ADDENDUM 1 TO REPORT ON

SOIL BACKFILL CONDITIONS

SAN ONOFRE NUCLEAR GENERATING STATION

JULY 12, 1983

Fig.
1

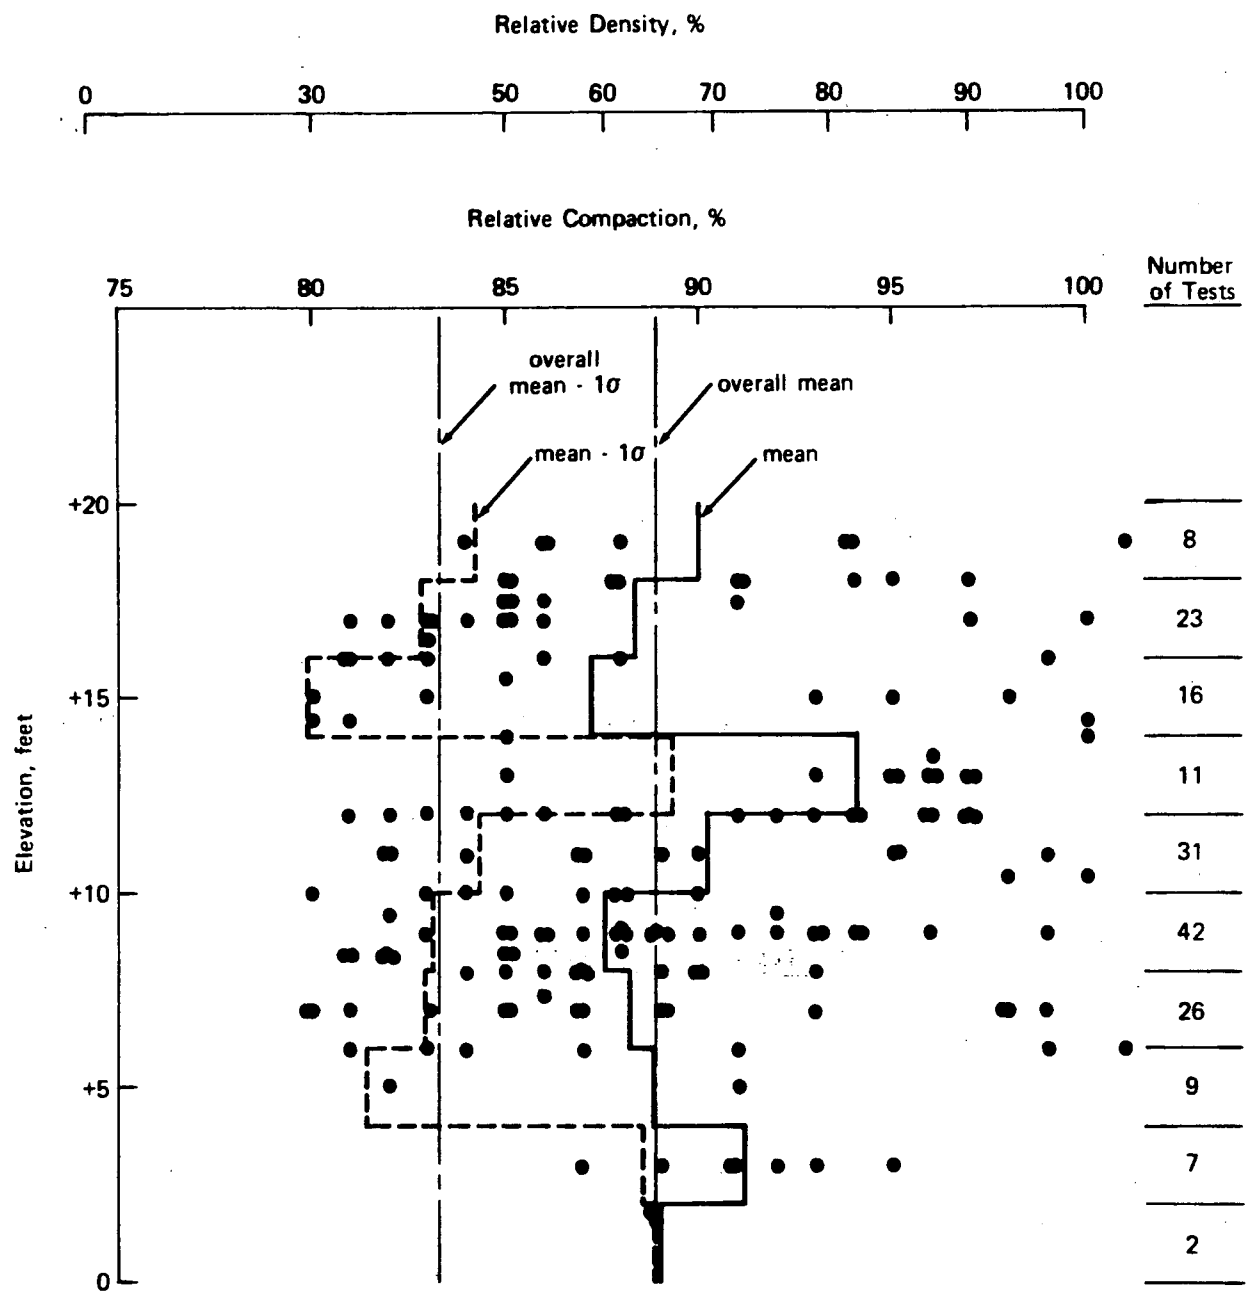
As shown by Figure 1, the overall mean and mean minus one standard deviation are about 89 and 83 to 84 percent relative compaction, respectively. The corresponding two-foot interval results and the distribution of data points show no specific trend with elevation. Further, as shown in Figure 1, 85 percent relative compaction corresponds to 50 percent relative density while 80 percent relative compaction corresponds to 30 percent relative density. It is considered unlikely that a soil deposit could remain at 30 percent relative density areally in a location such as the SONGS site where vibrations due to the operation of the power plant equipment or construction equipment have been almost continuous for over 15 years. Based on the aforementioned observation, the results of the 11 tests obtained at the east end of the Fuel Storage Building and on the lack in trend of density with elevation shown in Figure 1, it is concluded that 85 percent relative compaction is the appropriate value for use in settlement calculations.
